**BEFORE THE SELWYN DISTRICT COUNCIL
HEARINGS PANEL**

IN THE MATTER of Private Plan Change #76 by
Dunweavin 2020 Ltd on the Operative Selwyn
District Plan.

BRIEF OF EVIDENCE OF LISA MARIE WILLIAMS

13 October 2021

Figure 1: Amended ODP in response to Council Officers recommendations.

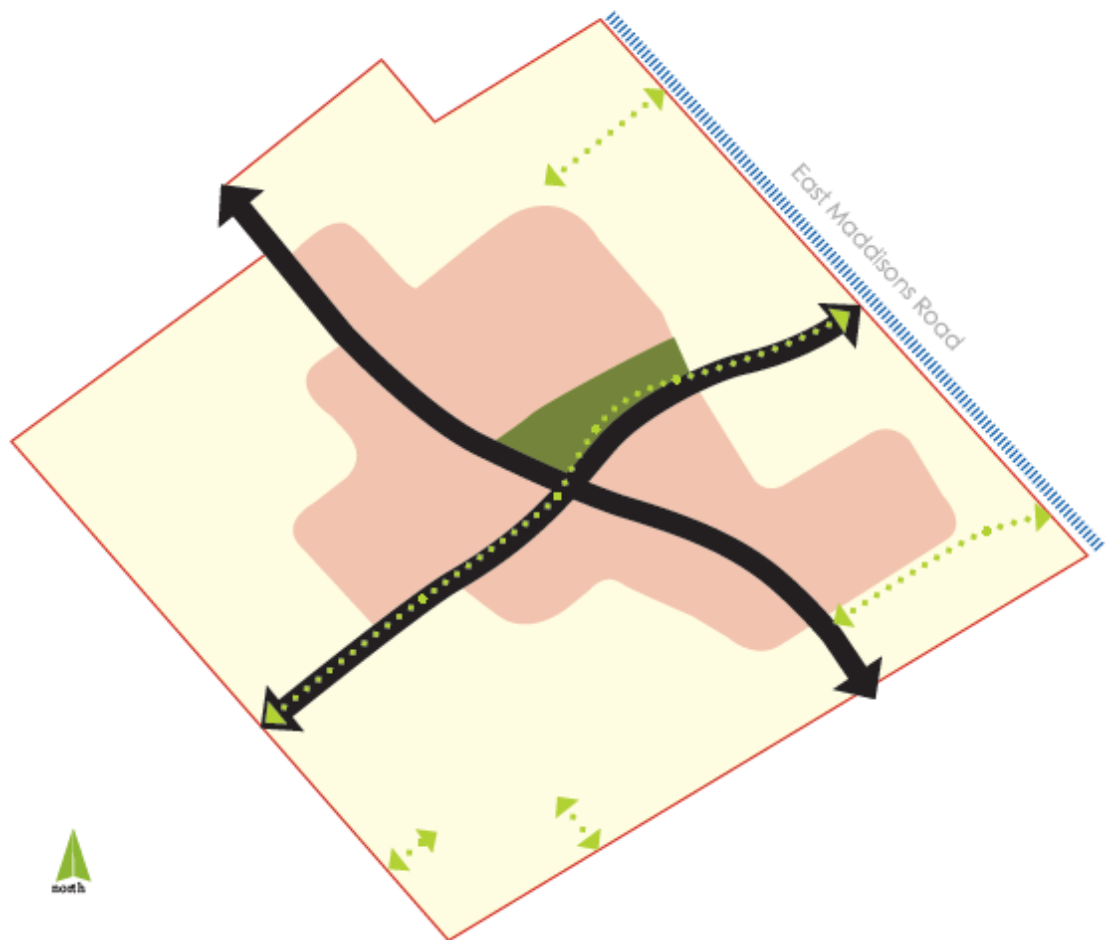
b. The ODP plan is amended to align the primary road network with PC76 with the roading network established in the subdivisions on the opposite side of East Maddisons Road.

c. The ODP plan is amended to illustrate a more direct east to west aligned road through the site.

d. The ODP plan is amended to illustrate the walking and cycling routes within the site, including an east-west cycle route.

7. The Outline Development Plan (ODP) has been updated in response to the Council Officers report. This includes a more direct alignment of the secondary road connection between East Maddisons Road and the land to the west, and additional of a shared path along this corridor. Pedestrian and cycle connections are also provided to East Maddisons Road near the northern and southern end of the ODP. This is shown in Figure 1 below. Additional commentary has also been added to the ODP narrative relating to the upgrading of the East Maddisons Road frontage to an urban form.

22. The ODP has been amended to provide a more direct alignment. It is noted that Mr Collins' evidence refers to this as a primary road, however this has been indicated as a secondary road in keeping with the hierarchy indicated on the Rolleston Structure Plan.

23. The ODP already indicates two walking and cycling connections to East Maddisons Road near the northern and southern ends of the ODP. In addition, a shared path has been indicated along the main East – West road connection.
